3 Volt Intel[®] Advanced+ Boot Block Flash Memory

28F800C3, 28F160C3, 28F320C3, 28F640C3

Specification Update

Order Number: 297938-014

1. 28F320C3xC Maximum I_{CCE} when $V_{pp}=12V$

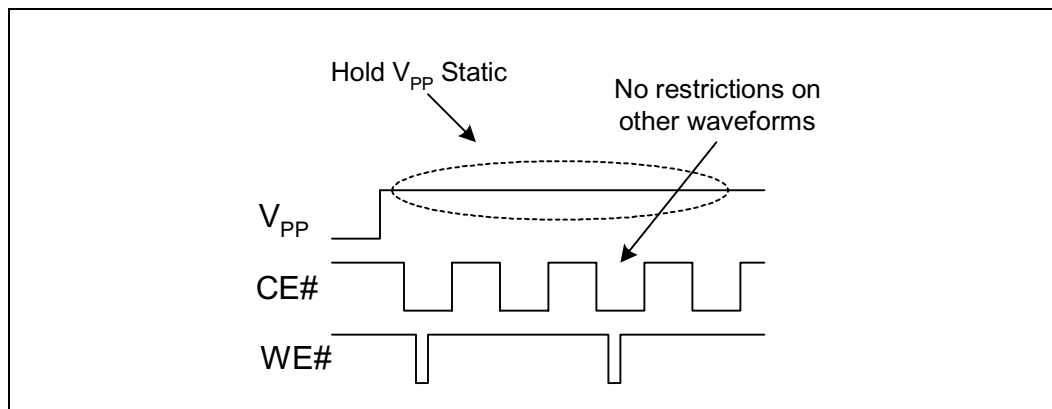
Problem: When $V_{PP}=12V$, I_{CCE} Max on 28F320C3xC devices on the 0.18 μ m deviates from the published specification and increases from 15mA to 25mA. The following is the revised specification for these products.

Implication: The increased current requirements may result in increased power drawn from the power supply during limited 12 V production programming. 3 V programming is unaffected.

Status: 32-Mb devices on the 0.18mm process are affected.

2. 28F320C3xC Reset Failure

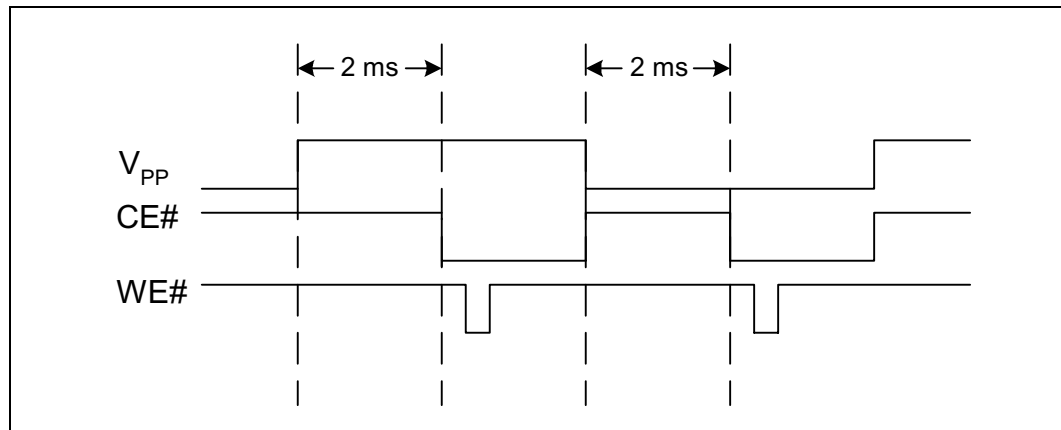
Problem: The 0.18 μ m 28F320C3xC devices can unintentionally reset under certain conditions where V_{pp} toggles.

Implication: When the reset occurs, any command being executed is interrupted and the flash switches to read array mode.

- 1) Tie V_{pp} to V_{CC} ;
- 2) If the third and fourth digits on the top side FPO mark (third line) is equal or greater than “23”, then V_{CC} may be set from 2.7v to 3.3v. V_{CC} must not exceed 3.3v
- 3) Set V_{pp} to a static high or static low level as shown here; and

4) Wait 2 ms after a V_{PP} transition to access the flash device, as shown here.

Figure 1. Workaround Placement

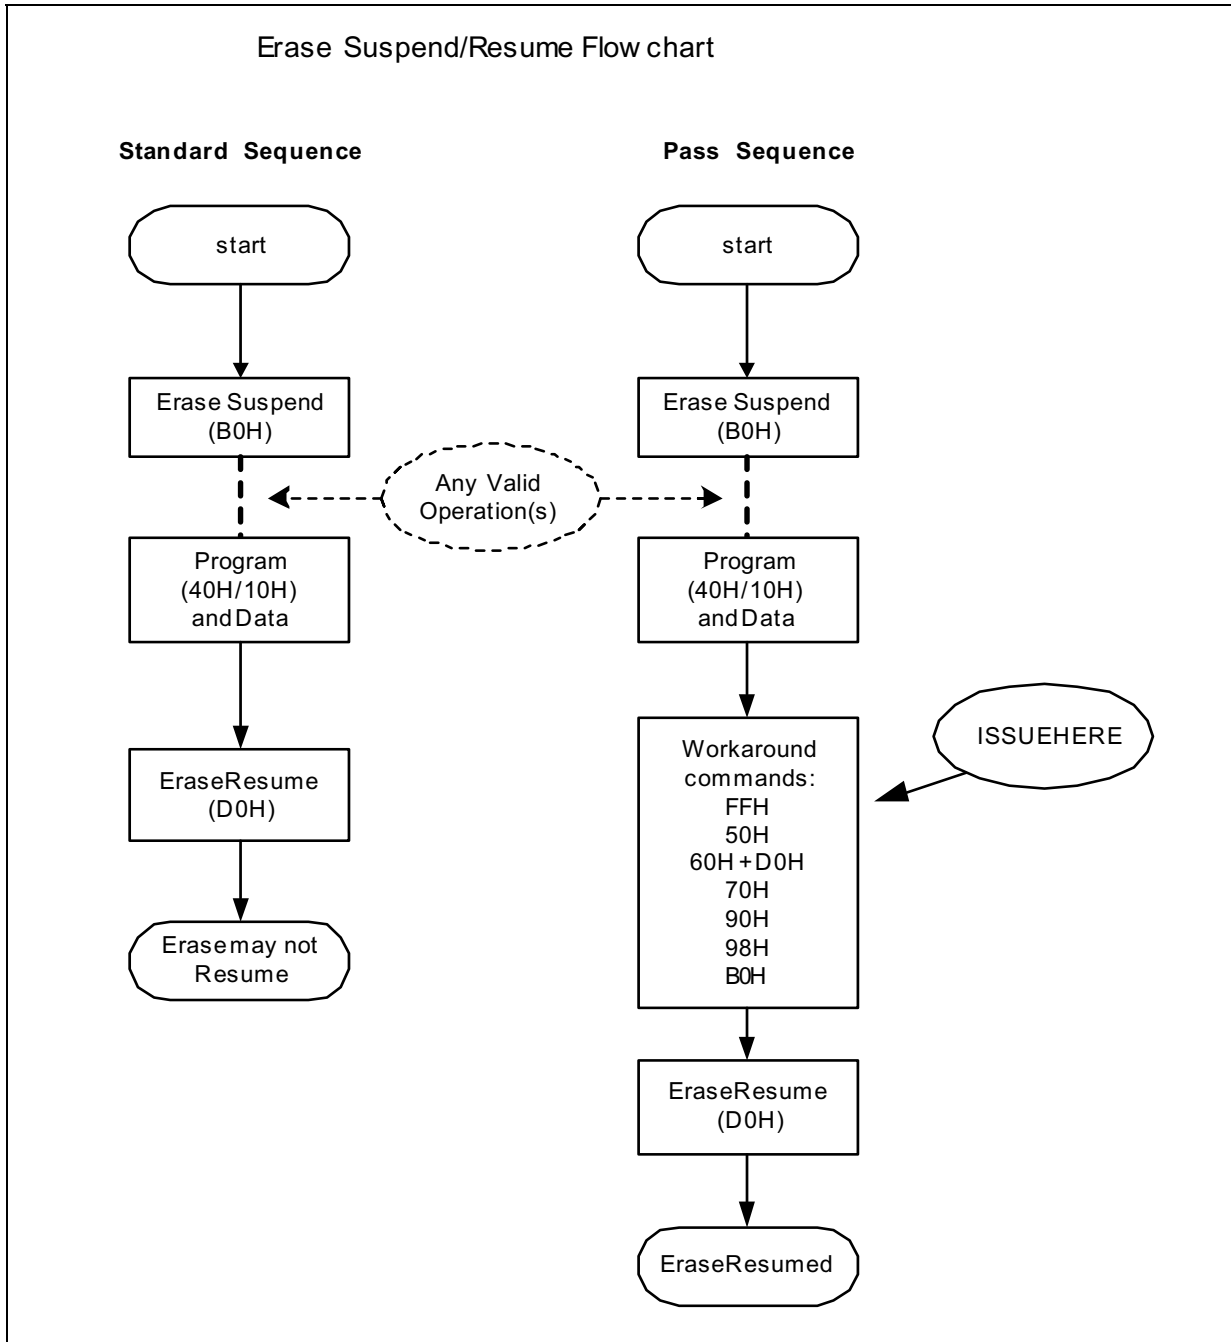
Problem: On the 0.18µm 28F160C3xC devices, a design anomaly was discovered. During an Erase-Suspend operation, if the Program (40H/10H) sequence is executed, under limited conditions the proceeding Erase Resume command (D0H) may not actually resume the device. No customers have reported failures in product applications. Customers who use any version of FDI (Intel Flash Data Integrator) software will not see this issue. If the Read Array command is issued prior to the Erase Resume command, users will not see the issue (typical in XIP applications).

Implication: The Resume Command (D0H) may be ignored by the device and will not correctly resume. The device will appear to remain in suspend (via status register). After a reset of the flash device the status register will clear. This failure has been recreated in a lab environment only.

1. If FDI (Intel Flash Data Integrator) software is used, users will not see the issue.
2. During an Erase-Suspend (B0H), user must issue any of the following commands after issuing the Program (40H/10H) and data sequence but before issuing the Erase-Resume (D0H) command.

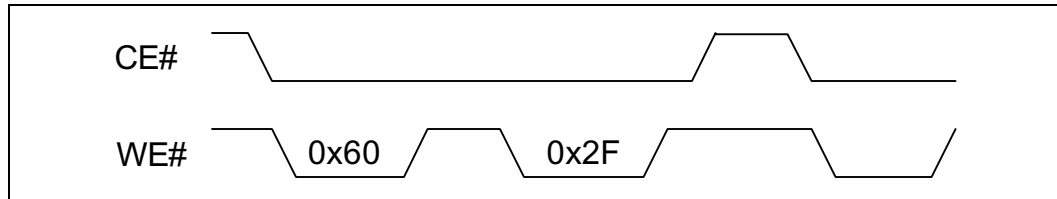
Problem: On the 16Mb and 64Mb 0.18µm devices, if CE# is deasserted after any block lock operation and before the next write sequence, the part may perform the same operation on additional blocks. (See waveform below.)

Implication: When CE# is deasserted after performing a block lock operation to a specific block and prior to the next write sequence, other blocks may perform the same operation.
